Stronger Together response to CEP Scoping Report, September 2025

Stronger Together to Stop Calderdale Wind Farm (ST) is a coalition of eight local groups who intend to prevent the construction of Calderdale Energy Park (aka Calderdale Wind Farm).

Peat model 2: Published September 2023 in the CWF Scoping Report

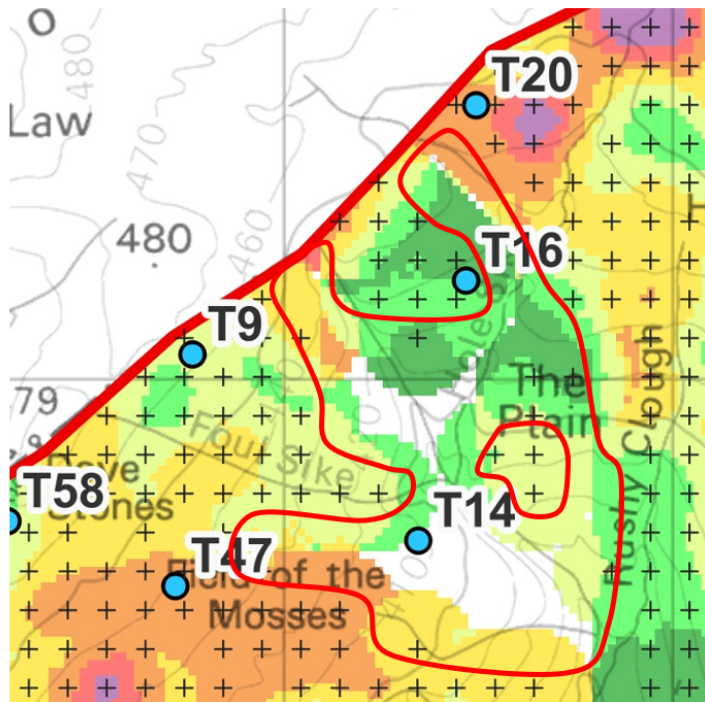
Peat Model 2 uses the superior Kriging algorithm to interpolate the depths found in the survey. It also shows the probing grid. Notice that probe points are shown outside the NE turbine area which correspond to the mapped hump in Peat Model 1. Natural Power should be strongly commended for publishing the probing crosses and for leaving some of the map blank where the probing carried out by TNEI had failed. Because of high standards pertaining at Natural Power, the Kriging algorithm did not colour the blank area west of Greave Clough (near T14) because the probing had failed there. The extent of the probing failure is clear from the absent crosses.

Inside the red area the colouring of the peat depths used to design the layout published repeatedly in the Scoping Report and Consultation Brochure is based on a wholly insufficient probing interval. The Kriging algorithm is guessing at depths based on distance depths. Once the distances are too great the algorithm does not attempt any colour and the map is left white.

Map 12A Detail of the Site Access Search Area over Crow Hill showing path of 1824 Crow Hill bog burst. Map: WTRG after SR 4-2]

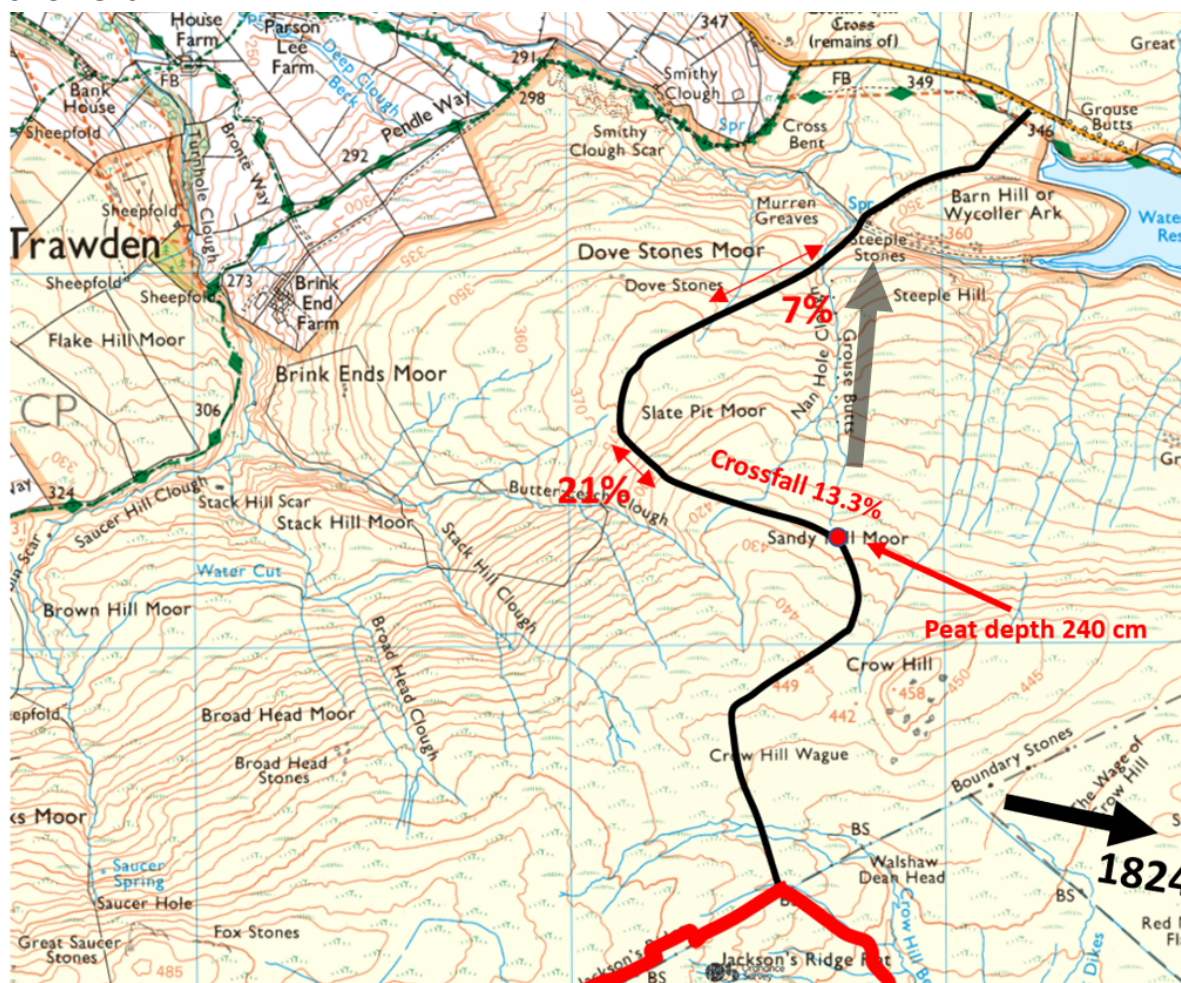
12.3.2 states that access to the turbine area for AIL will be by a new track. **4-2** has a map of the relevant Site Access Search Area and the brochure [[CB p 24](#)] for the non-statutory consultation gives a map of the Considered Access Route over Crow Hill. Neither map is adequate, so two maps are given in these comments. The route (black curve) over Crow Hill is shown on our Map 12A with the turbine area boundary (red), the search area borders (blue dashes) and the peat slide (thick black arrow) (**8.3.26**) known as the 1824 Crow Hill bog burst.

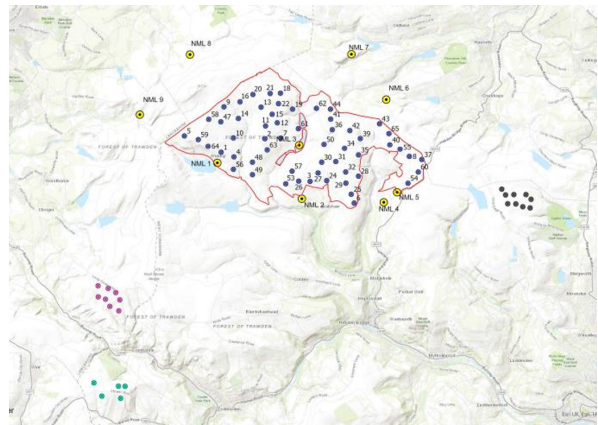
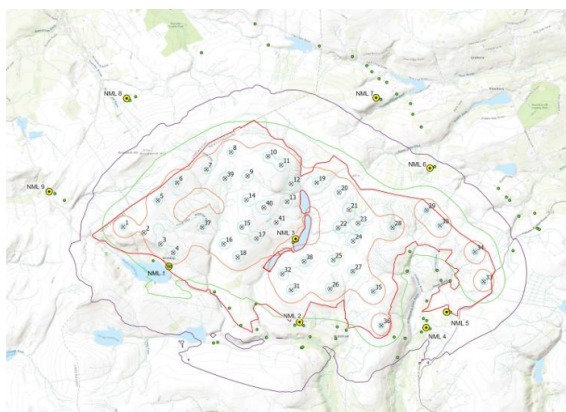
13.2 Figure 13-1 (Drawn by 'ST,' checked by 'MT' dated 19/08/2025) (below left) shows the result of modelling noise. It uses the layout for CEP presented at the [Non-statutory Consultation](#) on 29 April 2025 in the corrected version of 1 May 2025. Its last revision is 05, made on 29/08/2025.

Two completely different layouts, one of them “worse than useless”, have been used on adjacent maps revised on the same day.

13.4 The productions of ST and MT in SR must all be checked, corrected and published in a revised SR. An analysis of the work of ST appears below in our 13.20-13.25 below.

Map 13.7 When both assumptions of **13.3.5** are used, an unviable overcrowded wind farm results. Note the extreme overcrowding on Heather Hill (around T40) and especially in Black Clough (the cluster T21-T24).

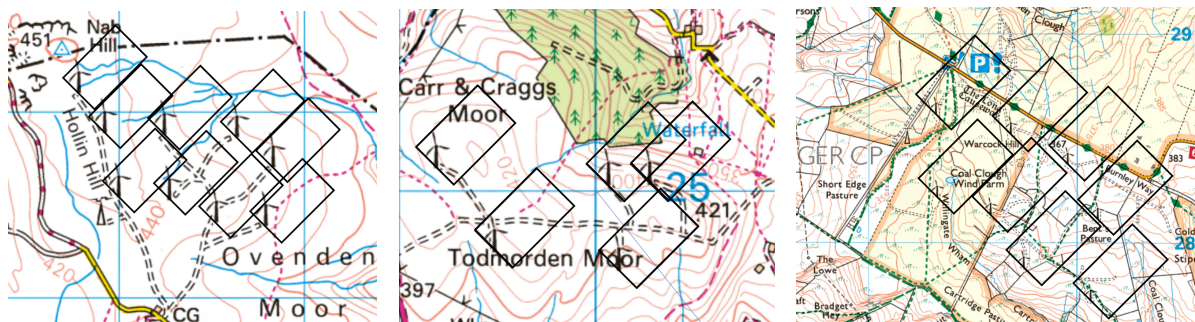
13.7 When the layout described in **13.3.5** is combined with the turbine type described in **note 291** (rotor diameter (RD) 162 metres) the result is gross overcrowding, particularly on Heather Hill and around Black Clough. One or other of the modelling assumptions in **13.3.5** must have been incorrect because the outcome of both assumptions used together is a grossly overcrowded wind farm. The figure below shows the minimum 3 RD by 5 RD footprints using the assumptions of the noise model in

13.3.5. In correctly spaced wind farms, there is almost no overlap between the footprints.

13.14 Before further comments can be made on the noise modelling methods of 13.3.5, a correct revision of the SR should assess noise using modelling assumptions that do not result in a grossly overcrowded wind farm, and revised maps that all relate to the correct proposal. Critical thinking must always be used when deploying cut-and-paste research.

Maps 13.8 a,b,c. The real wind farms shown in **13-2** are well spaced on 3 RD by 5 RD footprints.

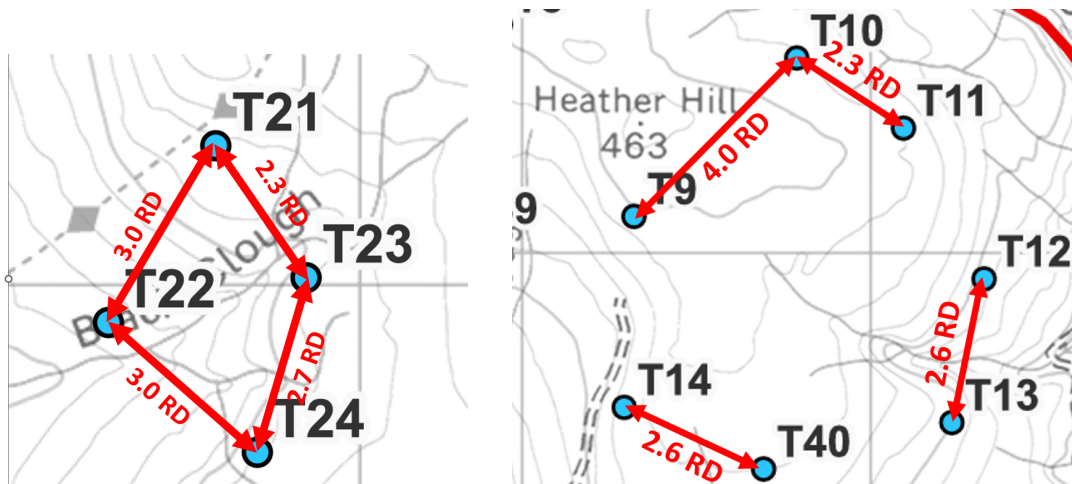
13.8 For comparison, the 3 RD by 5 RD spacings of the three real wind farms (Todmorden Moor, Coal Clough and Ovenden Moor) in the study area of **13-2** are shown below.

Map 13.9 Gross overcrowding in Black Clough and on Heather Hill.

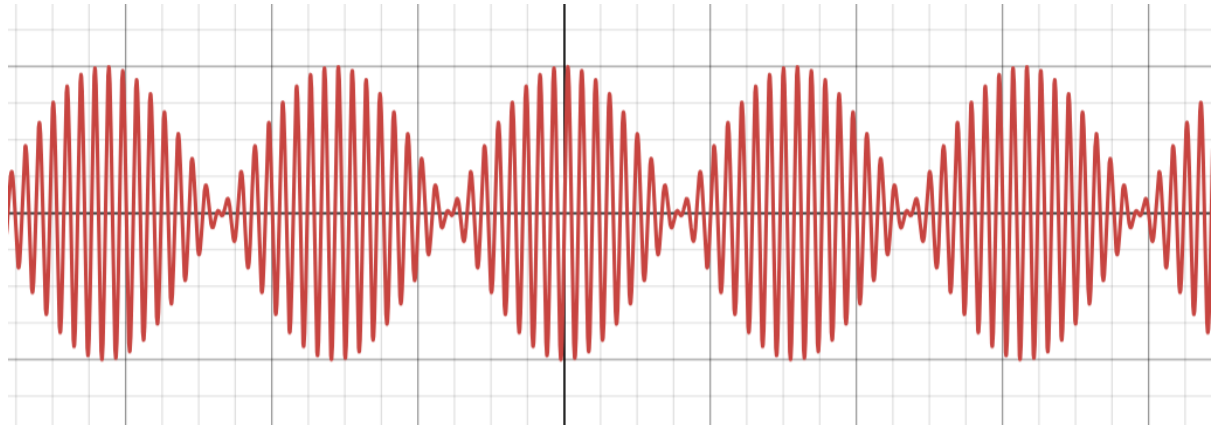
13.9 The simplistic windPRO modelling used in **13-1** cannot identify potential resonance tonal noise and amplitude modulation noise caused by the tight-packed turbines, especially those in Black Clough and on Heather Hill,

13.10 The modelling method of **13-1** is simplistic and finds noise intensity by the inverse-square-distance weighted average noise intensities of the array turbines. Some noise due to a grossly overcrowded array will usually be tonal noise in narrow frequency bands at resonant harmonics; or amplitude modulation noise caused by acoustic beats, the interference pattern of two sound sources of similar frequency in proximity. Neither of these array-determined features can be captured by the averaging method of **13-1**.

Fig 13.23 Pop-up notification of the T42 error. Image: CWF Ltd

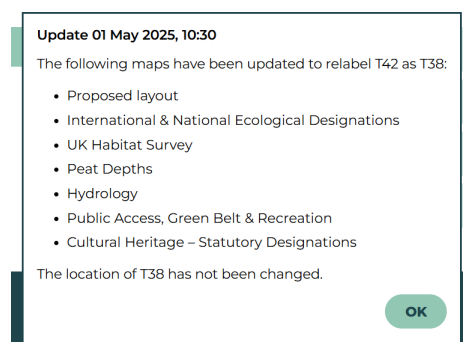
13.23 **18-1** on Shadow Flicker (drawn by 'ST' and checked by 'MT') has a T42 but no T38. The same error on all seven maps published for the non-statutory consultation on 29 April 2025 was brought to the attention of the CWF Ltd Project Director on 1 May 2025 by a member of the public, who was thanked in writing. The error was then corrected on seven maps produced for non-statutory consultation, with a pop-up notification of the corrections to seven erroneous maps that has recently been taken down but is shown below.

The revision dates on **18-2** all long postdate the acknowledgment of the error by the Project Director, and why the error persists in **18-2** should be explained by the Project Director, but expert users of windPRO will know how a poorly trained user with no overall understanding of the proposal and its document history might make this error. Logika should explain why the error was not caught by the more experienced chapter and volume editors, and CWF Ltd. should explain why it was not caught by the Project Director, who was acutely aware of the T42 problem following the events of 29 April-1 May 2025.

13.25 Logika and CWF Ltd. should want to guarantee the correctness of all the maps in subsequent revisions of the SR submitted to the Secretary of State. Consultees and investors whose time and money has been wasted by this SR should be given an explanation for the authorship, drafting and checking failures, and clear lines of management and accountability at Logika should be published in subsequent revisions of the SR.
